Thermostat Internal
Schematic

Vapor Thermostat
Modifications and
Connection Diagram

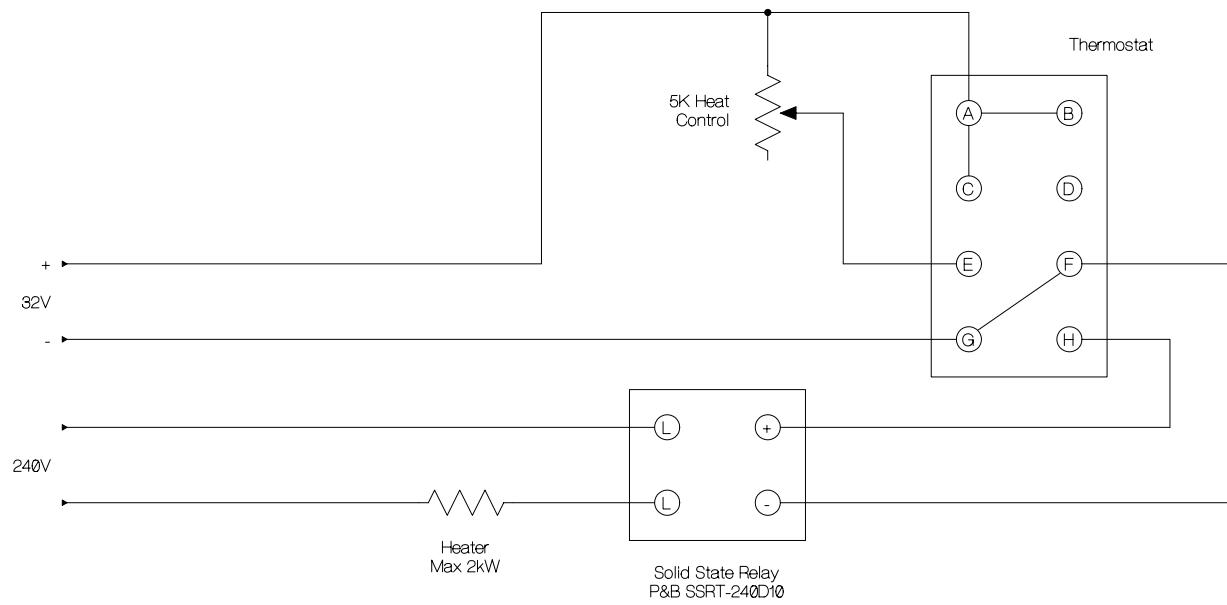
Note: Thermostat internal wiring must be altered. Remove jumper between G and H and add wire from N/O contact (opposite D) to terminal H.
